SAFETY BULLETIN THE UK LIFT COMPANY LTD CIBES 5000/7000 ADJACENT ENTRY LESS ABLED ACCESS PLATFORMS

Health & Safety Technical Information Bulletin.

TITLE: - Potential Safety Hazard with Motorised Lock Release for Long Side Door in Adjacent Entry

REF: - Cibes 5000 / 7000 Adjacent Entry Less Abled Access Platforms (only).

Diagram shows Typical Adjacent Door Layout

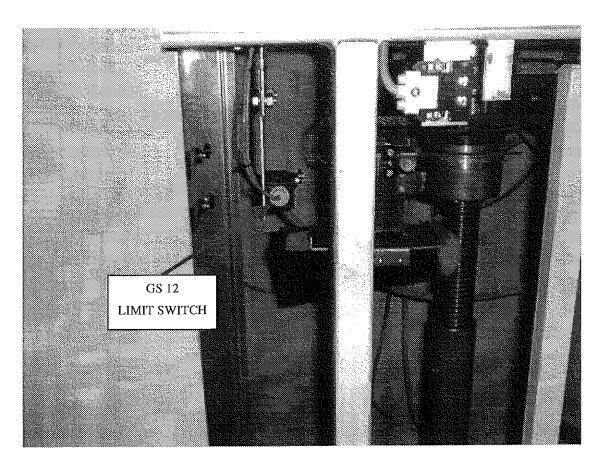
Where a long side door is fitted (door opposite platform push buttons), switch GS12 is mounted on the moving platform rear frame, which operates to unlock the upper door(s) via a linear actuator.

GS12 switch is mounted just to the left hand side of the screw and can be viewed when the platform is at its lowest position with the platform access panel removed. (See attached photo)

CAUTION must be used however when conducting maintenance or inspection procedures, as if this switch is manually triggered when the supply is live the long side door locking bolt will retract, unlocking the door. As the platform will be at the lowest point the unlocked door will be above and thus creates potential access to the shaft when the platform is not at that floor level.

Visiting engineers / inspectors must ensure they do not operate GS12 limit switch when the platform is anywhere other than at the floor that serves this door release layout. The mains power should of course be isolated before gaining access to the maintenance access panel and therefore the components behind this panel, thus stopping any potential operation of the linear motor.

This safety issue will be engineered out by July 2003 so it only applies to machines manufactured before this date.
